DOCUMENT 009214 – INTERIORS PACKAGE ADDENDA – NO. 1

- A. Project Name: St. Patrick Catholic Church.
- B. Construction Manager: Kingery Construction.
- C. Architect: Clark Architects Collaborative 3.
- D. Architect Project Number: 11008.
- E. Date of Addendum: 11-12-14

Addendum 01 - Int. Package
11-12-14
AAD-10.0

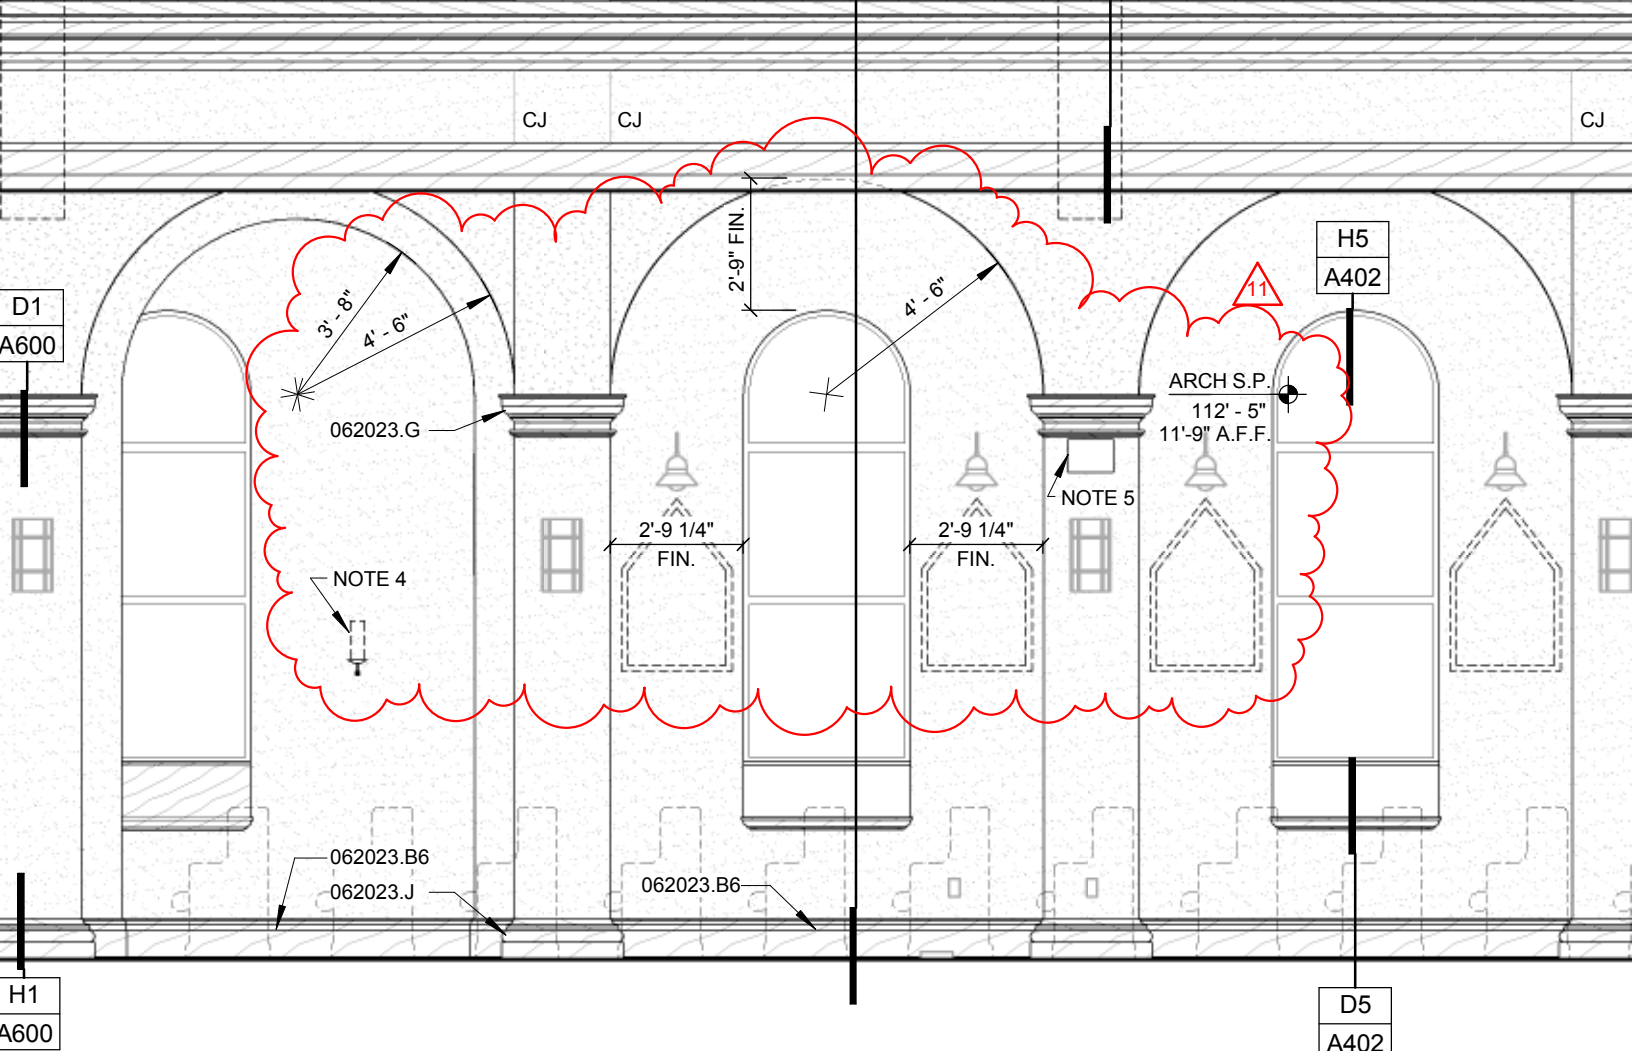
- E. Sheet A500 – Interior Elevations (not reissued).
1. Revised Elevation A1. See attached AAD-10.0:
 - a. Revised fire alarm location - to be mounted directly below pier capital. See this Addendum 01 notations on sheet E202.

- b. See Note 4 for dedication candle notation.
 - c. Windows F and K shall be located with sill masonry opening at project elevation 104'-8". As a result, top of pier capitals as well as the ceiling arch springpoints shall move up four inches to 11'-9" above finished floor. Flat portion of main side isle ceilings shall move up four inches to 16'-8" above finished floor. Flat portion of side isle ceiling ribs shall move up four inches to 16'-4" above finished floor.

- d. Radius of inner arches at Transepts shall be 3'-8" in lieu of 4'-0" to cover the structural beam spanning the Transept openings.
 2. Revised Elevation H1 – Springpoint of ceiling arch to be 11'-9" above finished floor in lieu of 11'-5". Radius of arch to be 3'-8" in lieu of 4'-0".

NOTE 4: DEDICATION CANDLE (10 TOTAL) - BY OWNER. GC TO PROVIDE REQUIRED BLOCKING.

NOTE 5: TOP OF SMOKE ALARMS TO BE MOUNTED AT 10'-10" ABOVE FINISHED FLOOR AT PIERS NEAR GRID INTERSECTIONS A-11, G-11, A-14, AND G-14.

Addendum 01 - Int. Package
11-12-14
AAD-11.0

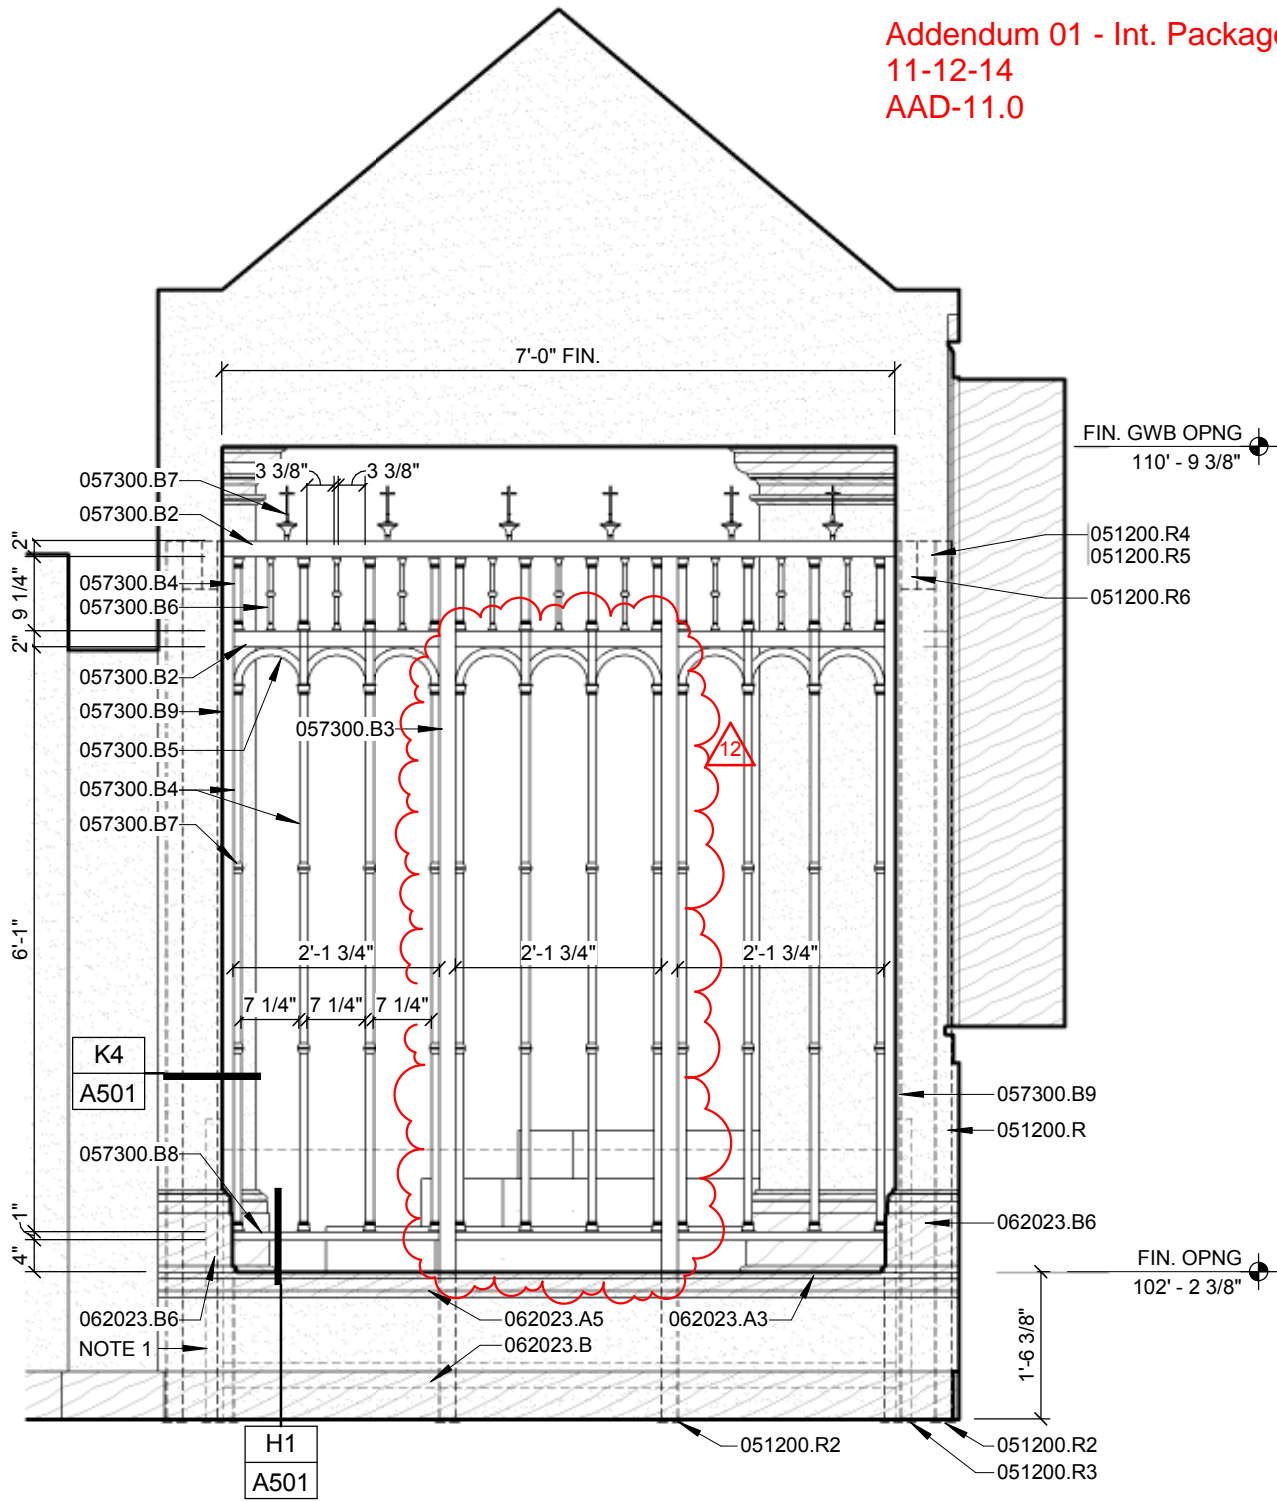
- F. Sheet A501 – Interior Elevations (not reissued).
1. Revised Elevation H6 – No door in Chapel gate. See attached AAD-11.0.
 2. Revised Elevation H10 – Springpoint of ceiling arch and top of pier capital to be 11'-9" above finished floor in lieu of 11'-5". Radius of arch to be 3'-8" in lieu of 4'-0".

Addendum 01 - Int. Package
11-12-14
AAD-12.0

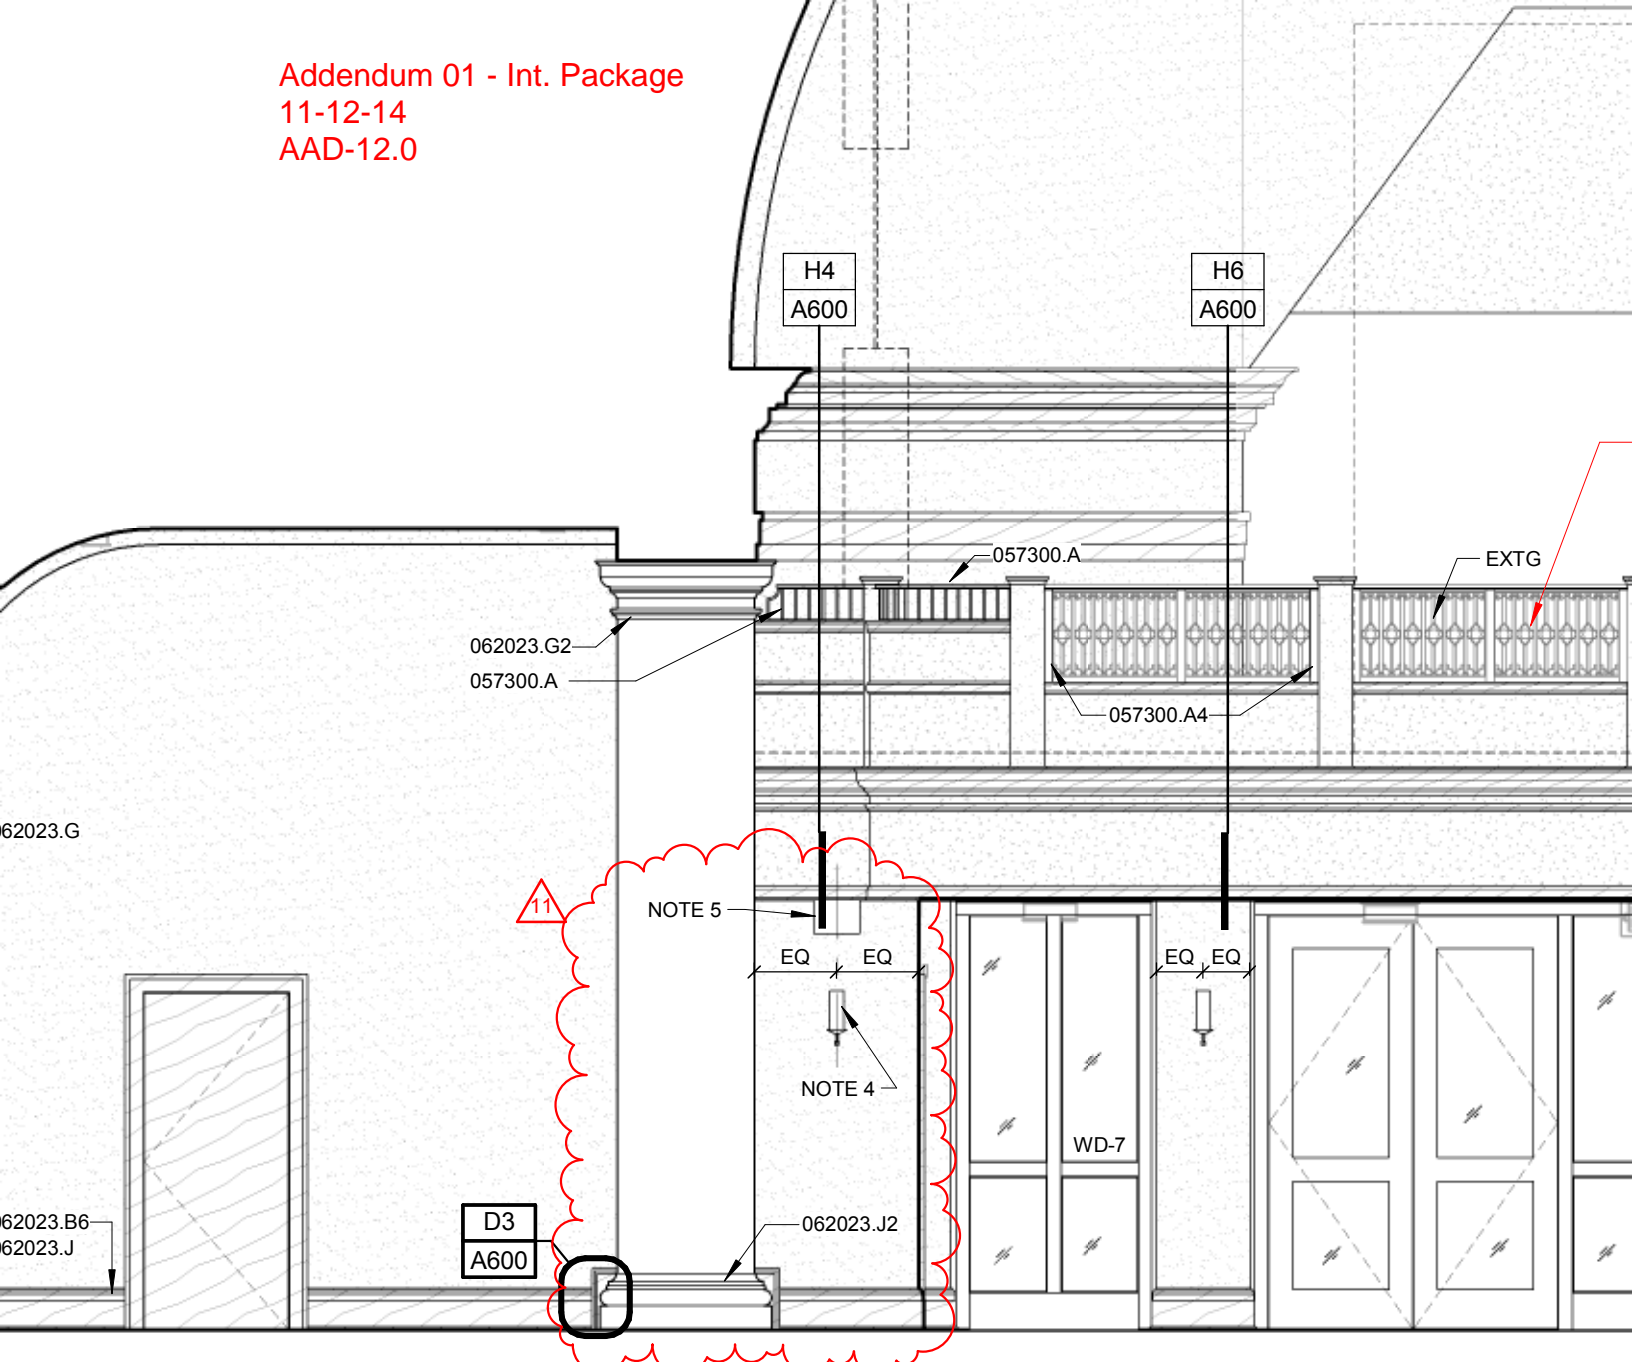
- G. Sheet A502 – Interior Elevations (not reissued).
1. Revised Elevation H6 – Remove sister piers from side of main piers. Revised fire alarm locations – to be mounted directly below Choir Loft ceiling. See this Addendum 01 notations on sheet E202. See attached AAD-12.0.

NOTE 5: TOP OF SMOKE ALARMS TO BE MOUNTED AT 8'-11 1/4" ABOVE FINISHED FLOOR AT GRIDS B-8 AND F-8.

Addendum 01 - Int. Package
 11-12-14
 AAD-13.0

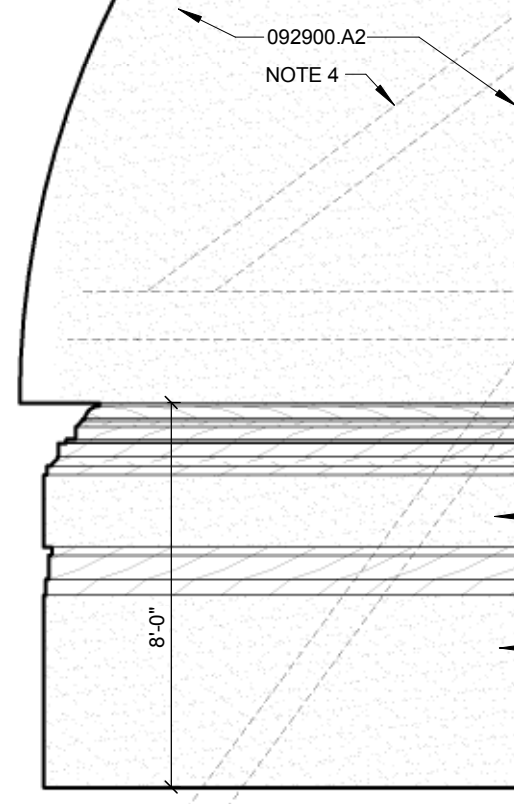
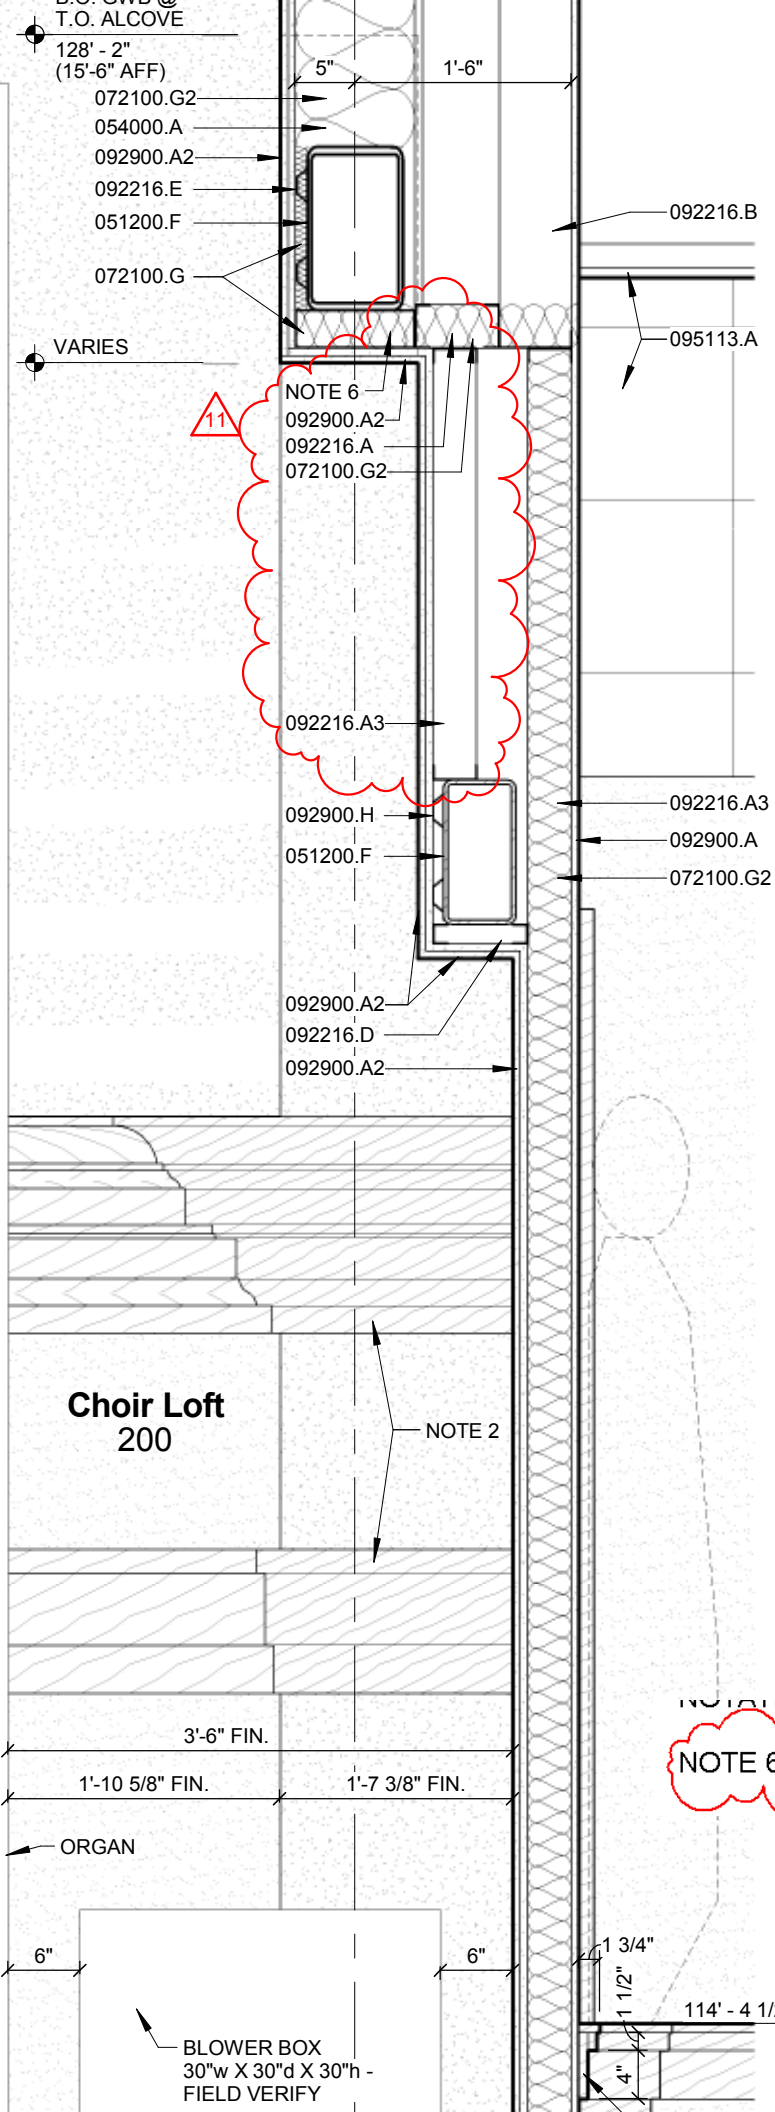
- H. Sheet A601 – Interior Details (not reissued).
1. Section Detail C5 - Revised recess behind organ. Gypsum wall board to continue straight up above beam in lieu of turning back. See attached AAD-13.0.

Addendum 01 -
 Int. Package
 11-14-14
 AAD-14.0

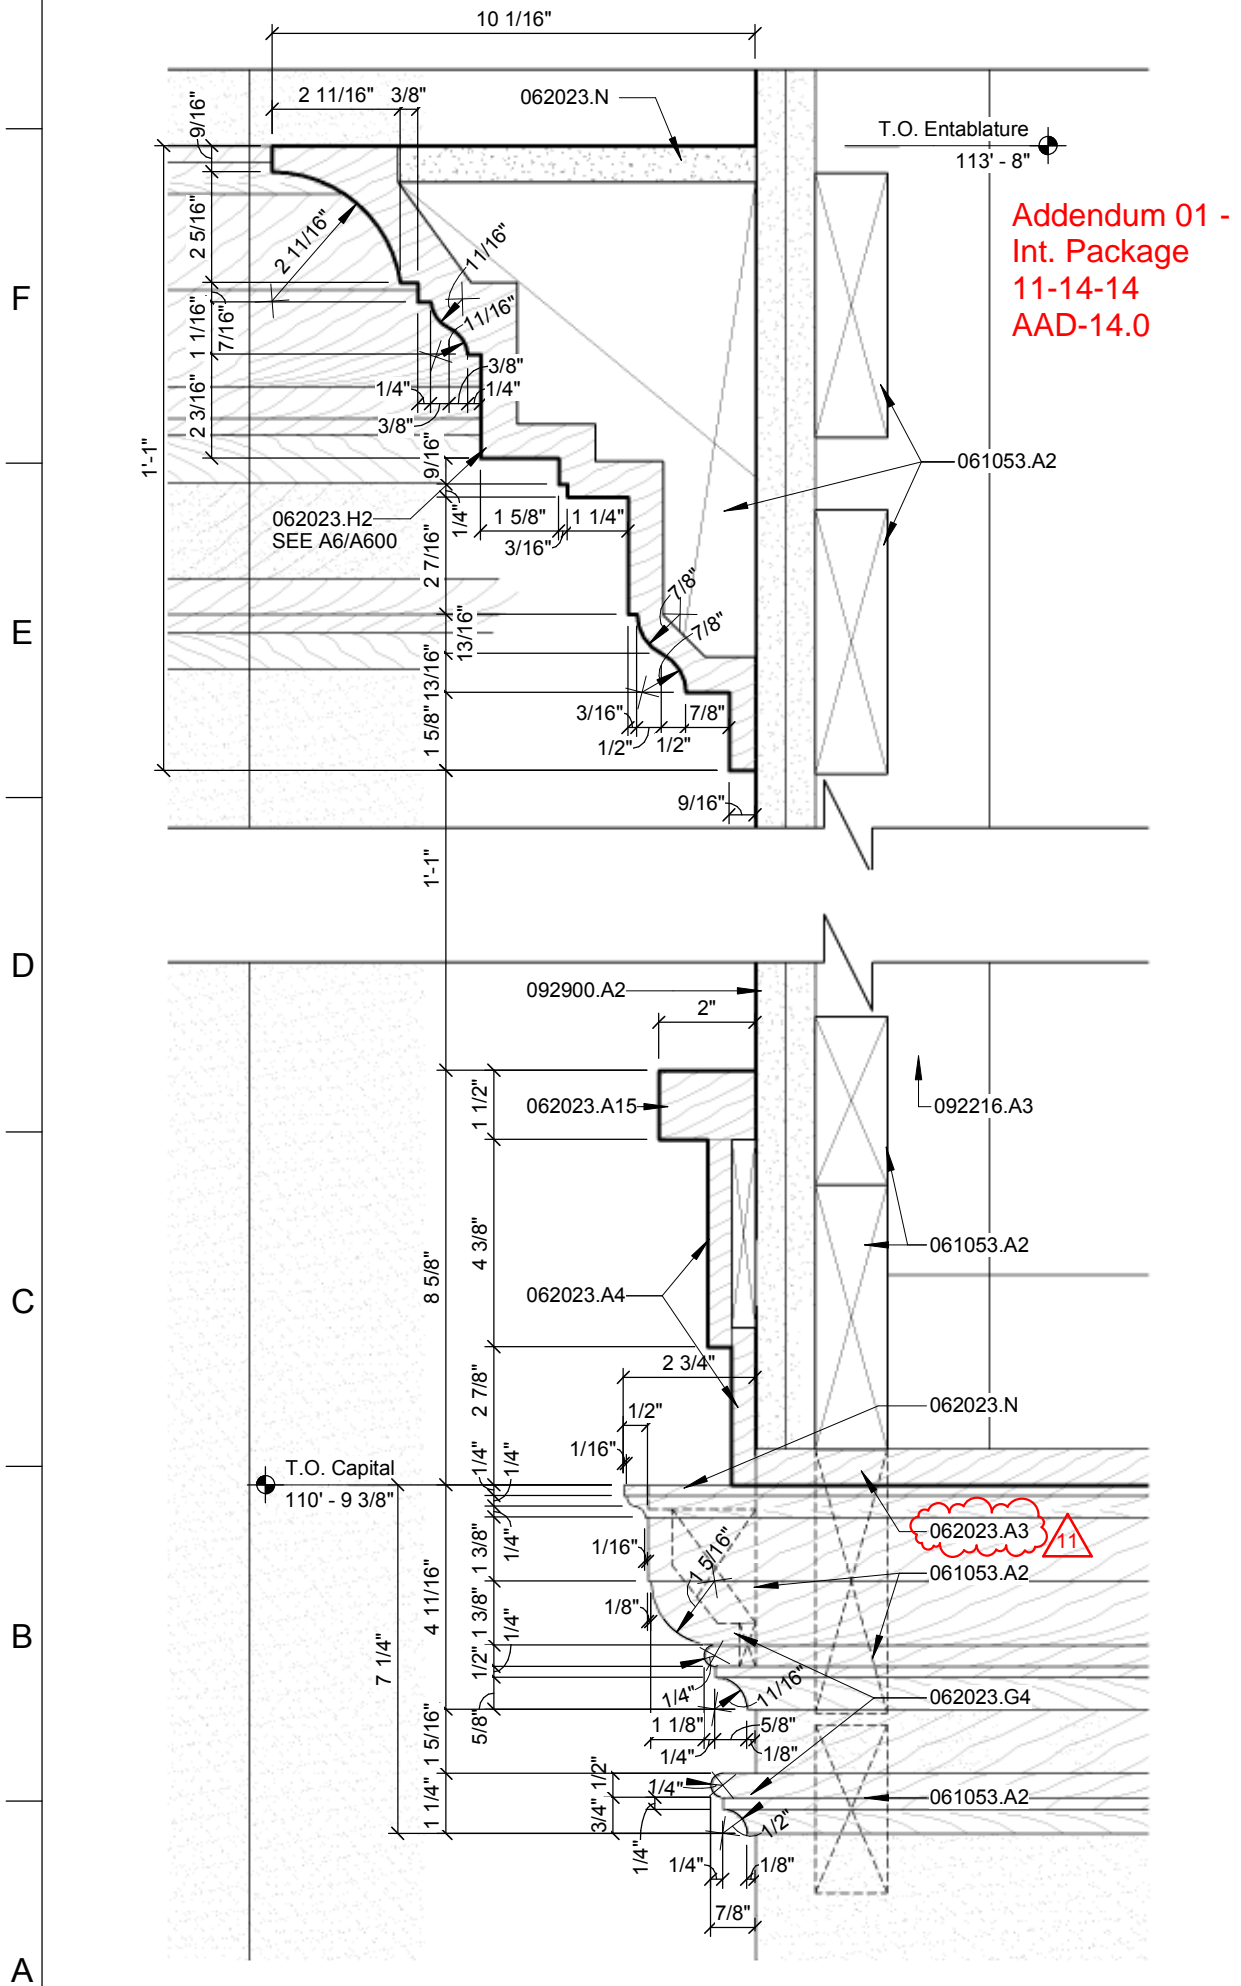
2. Section Detail A1 - Revised bulkhead at Sanctuary with a wood soffit in lieu of two layers of gypsum wallboard and acoustical plaster finish. See attached AAD-14.0.
